Subject: Response to NRC Request for Additional Information on License Amendment Request No. 8 to Holtec International HI-STORM 100 Certificate of Compliance No. 1014

Holtec's Response to
Request for Additional Information
on LAR 1014-8

Figure 3-2.1: Fuel Loading for 0° and 45° Basket Orientations

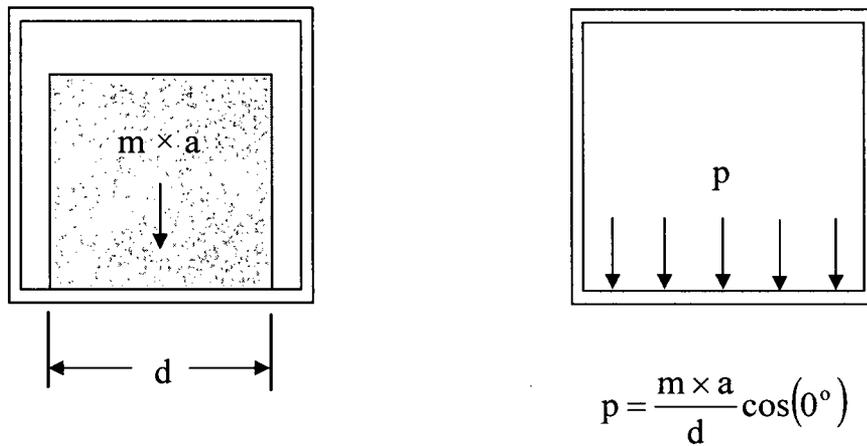
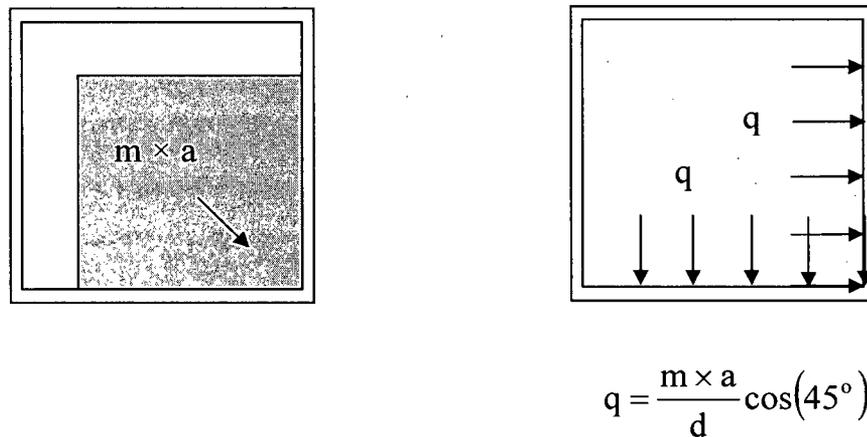
a) Provide analyses for different basket orientations for side drop analysis.

Holtec Response: Per Section 2.III.0.1 of the LAR, the structural acceptance criterion for the MPC-68M basket is defined in terms of the maximum lateral deflection of a basket panel under accident loading conditions. Thus, the limiting accident event is the one which causes the maximum lateral deflection of a basket panel relative to its end supports. Since the lateral deflection is proportional to the lateral load on a basket panel, the limiting accident event can also be viewed as the one which maximizes the lateral load on a single basket panel. For the MPC-68M fuel basket inside a HI-STORM overpack, the lateral load on a single basket panel is maximized during the non-mechanistic tip-over event with the fuel basket in the 0° circumferential orientation.

In the 0° orientation, the amplified weight of each stored fuel assembly (during the 70g impact event) bears entirely on one basket panel. Conversely, in the 45° orientation, the amplified weight of each stored fuel assembly is equally supported by two basket panels. The difference in loading between the two basket orientations is pictorially shown in Figure 3-2.1 below, where “m” denotes the fuel assembly mass, “a” denotes the maximum lateral deceleration, and “d” denotes the enveloping size of the fuel assembly. For comparison purposes, the pressure loads on the basket panels are denoted as “p” and “q”, respectively, for the 0° and 45° orientations. From the figure, the pressure load p that develops in the 0° orientation is 41% greater than the pressure load q that develops in the 45° orientation. Hence, the lateral deflection of a basket panel is much greater for the 0° orientation, which is why the 0° orientation is chosen for analysis in Section 3.III.4.4.3.1. It is also noted that the 90° corners where the basket panels intersect do not provide any additional moment resistance because of the slotted joint construction (see Figure 1.III.1 in LAR); therefore, the 45° orientation does not give rise to any prying loads at the cell corners. Finally, to ensure that the analysis performed in Section 3.III.4.4.3.1 for the 0° orientation is conservative and bounds all other basket orientations, the analysis is performed based on a lateral impact deceleration of 70g even though, according to the results presented in Section 3.III.4.10 of LAR, the maximum impact deceleration due to the non-mechanistic tip over event (measured at the top of the overpack lid) is less than 45g.

In summary, the 0° orientation is the most limiting orientation for the design and analysis of the MPC-68M fuel basket since it maximizes the load transmitted to a single basket panel. Therefore, the 0° orientation is the focus of the analysis presented in Section 3.III.4.4.3.1 of the LAR. Nevertheless, to further ensure that the finite element results for the 0° orientation bound all other basket orientations, the analysis is carried out using a bounding deceleration load of 70g.

Section 3.III.4.4.3.1 of the LAR has been revised to include this information.

Figure 6.III.4.1 Assembly Cross Sections

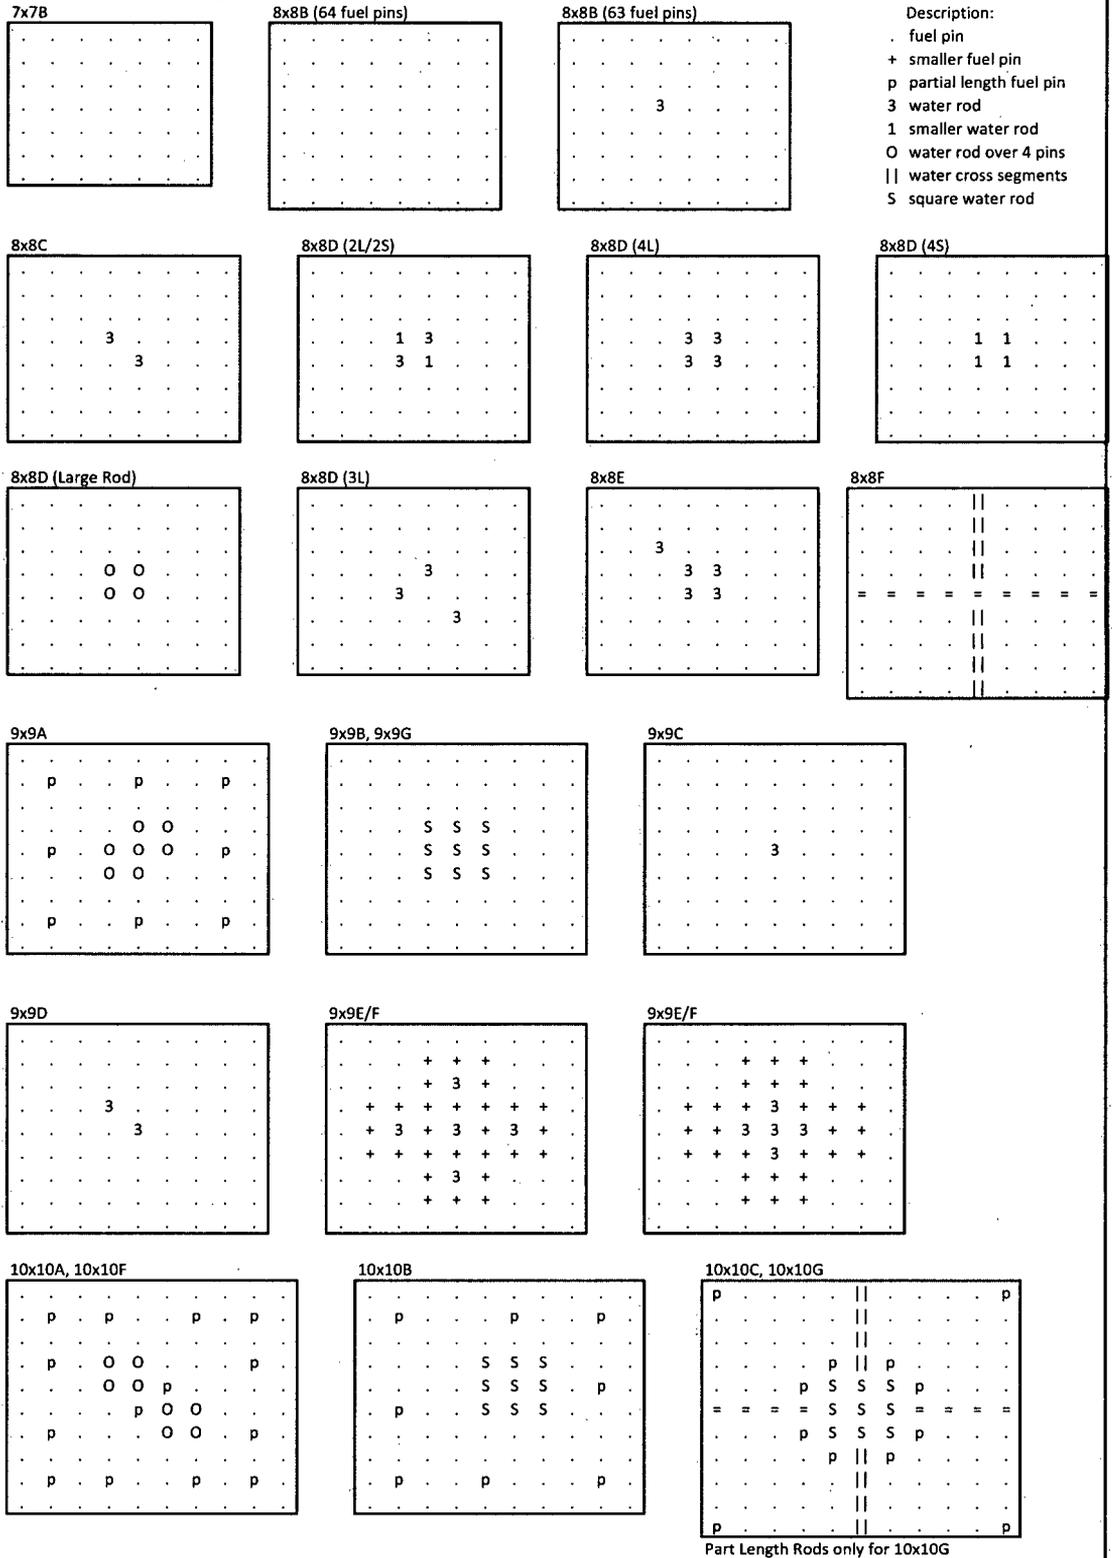
For the 9x9E and 9x9F Note 13 in Table 2.1.4 of the FSAR says: For the SPC 9x9-5 fuel assembly, each fuel rod must meet either the 9x9E or the 9x9F set of limits or clad O.D., clad I.D., and pellet diameter. Provide additional information justifying that the criticality analysis for the MPC-68M was performed considering the most conservative set of fuel specifications.

A schematic diagram has been added in Supplement 6.III, Section 6.III.4, that identifies the location of the different rod types in the assembly that is used in the analysis. Note that there are two known patterns of water rod locations for this assembly type. A new study in Subsection 6.III.4.2 verifies that the more conservative pattern is used in the design basis calculation (see Table 6.III.4.3).
